## 2.15 Structures and Servicing Systems

The information in this section of the reference ABWR DCD, including all subsections, tables, and figures, as modified by the STP Nuclear Operating Company Application to Amend the Design Certification rule for the U.S. Advanced Boiling Water Reactor (ABWR), "ABWR STP Aircraft Impact Assessment (AIA) Amendment Revision 3," dated September 23, 2010 is incorporated by reference with the following departures.

### 2.15.5 Heating, Ventilating and Air Conditioning Systems

Table 2.15.5c Reactor Building Safety-Related Equipment HVAC System

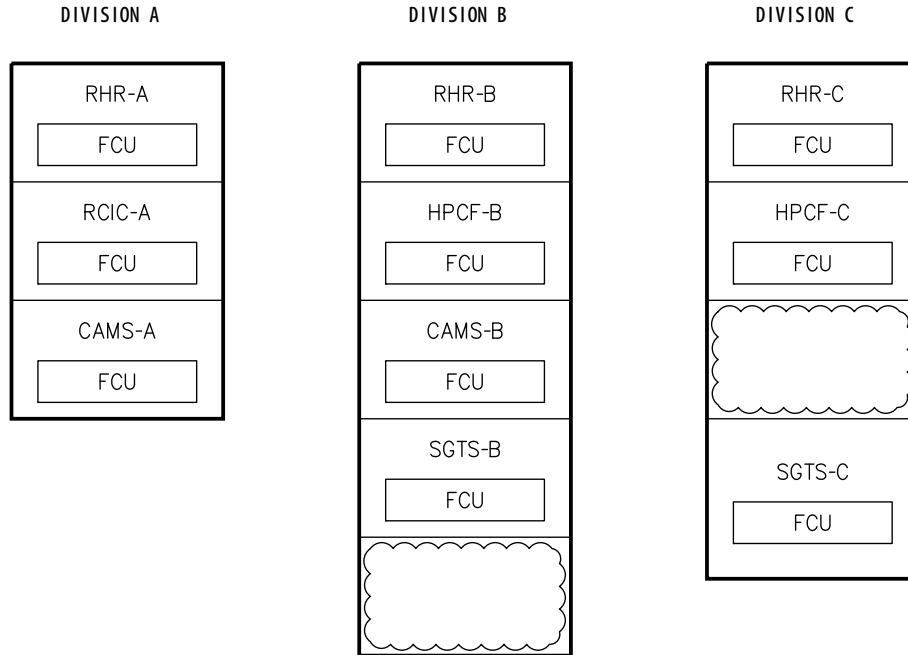
Inspections, Tests, Analyses and Acceptance Criteria		
Design Commitment	Inspections, Tests, Analyses	Acceptance Criteria
<del>4. The FGS room FCUs are initiated upon a manual FGS start signal. Not used.</del>	<del>4. Tests will be conducted on each as built FGS room FCU using a simulated initiation signal. Not used.</del>	<del>4. The FGS room FCU starts upon receipt of a signal indicating FGS start. Not used.</del>

**Figure 2.15.5e Reactor Building Safety-Related Equipment HVAC System**

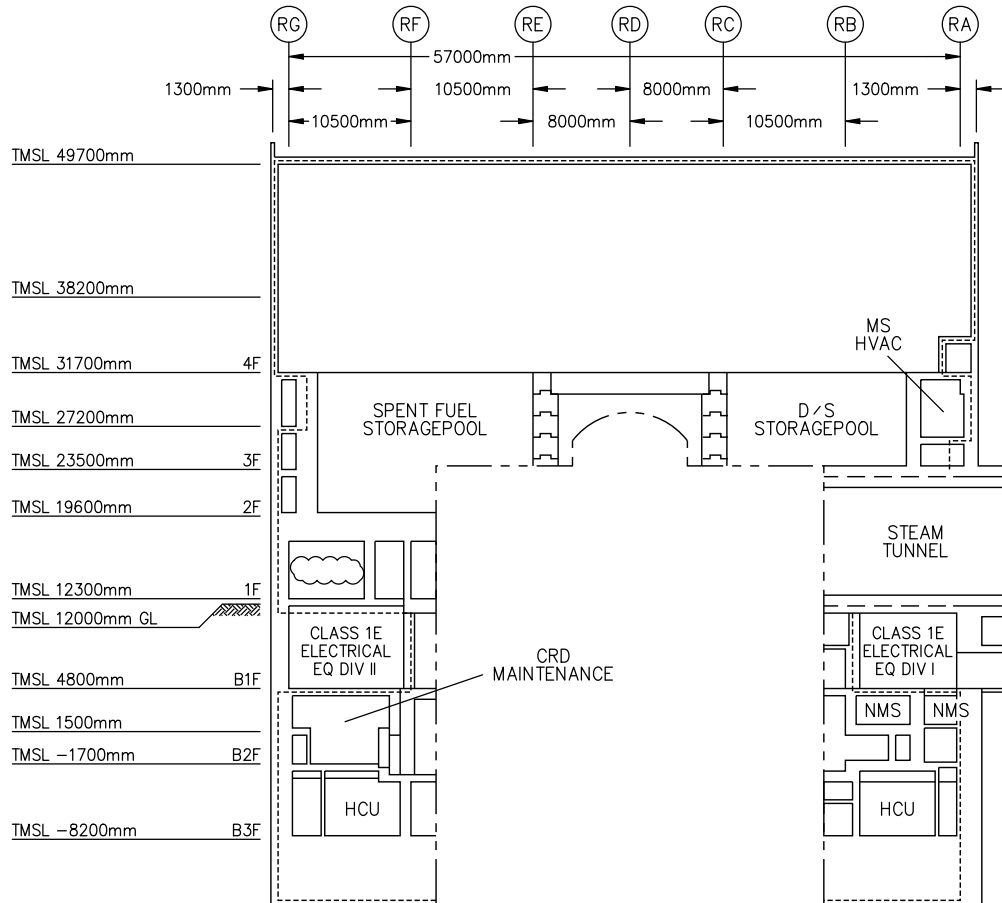
STD DEP T1 2.14-1 (Figure 2.15.10a, Figure 2.15.10j, Figure 2.15.5e, Table 2.15.5c)

*The R/B Safety-Related Equipment HVAC System provides cooling of safety-related equipment areas, and consists of independent fan coil units. Figure 2.15.5e shows the basic system configuration and scope.*

*The Residual Heat Removal (RHR) System, High Pressure Core Flooder (HPCF) System and Reactor Core Isolation Cooling (RCIC) System pump room FCUs are automatically initiated upon startup of their respective room process pump. The Containment Atmospheric Monitoring System (CAMS) and Standby Gas Treatment System (SGTS) room FCUs are automatically initiated upon isolation of the Reactor Building Secondary Containment HVAC System. ~~The Flammability Control System (FCS) room FCUs are also initiated upon a manual FCS start signal.~~*

Figure 2.15.12a Control Building Arrangement, Section A-A

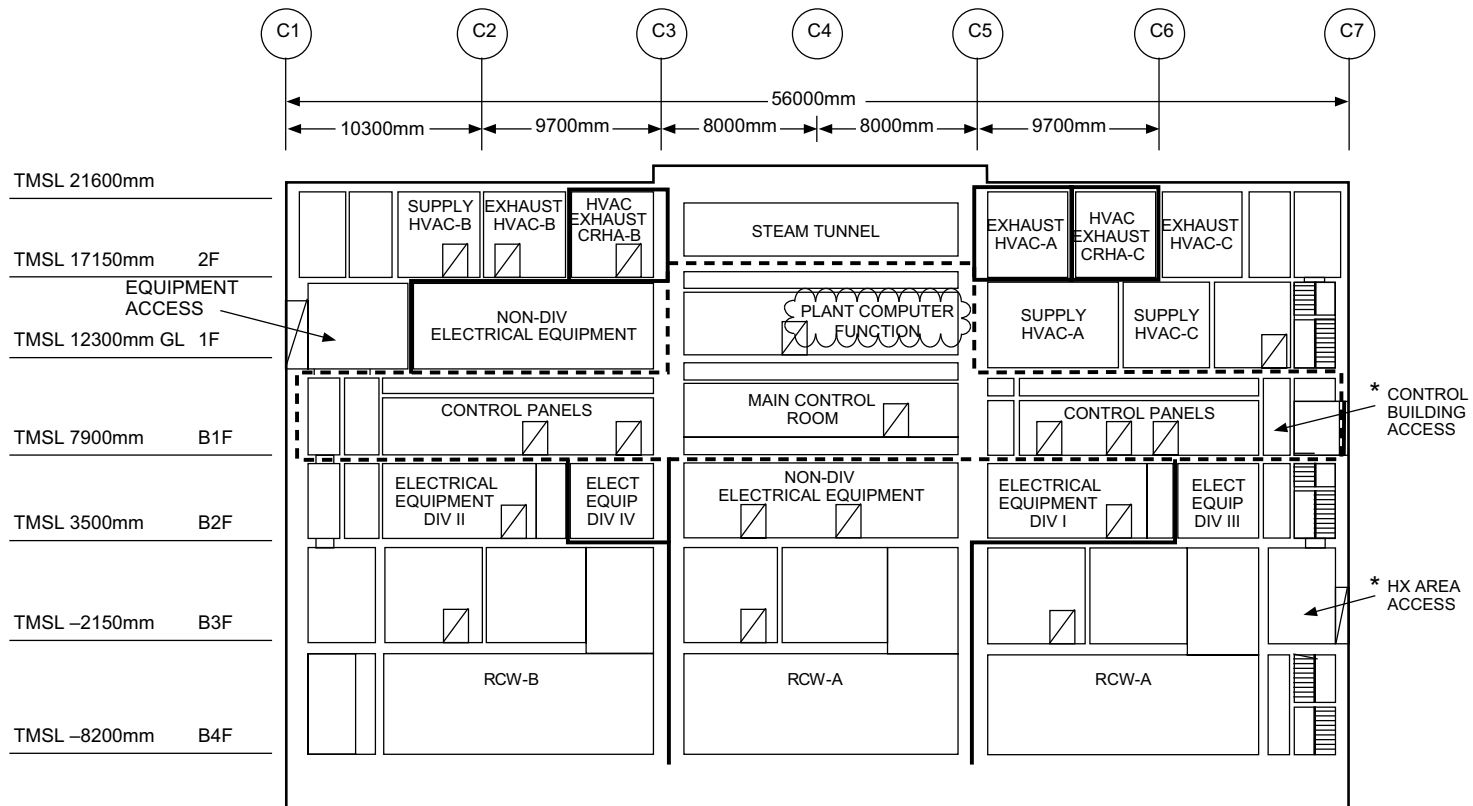
STD DEP T1 3.4-1 (Figure 2.15.12a, Figure 2.15.12b, Figure 2.15.12g)
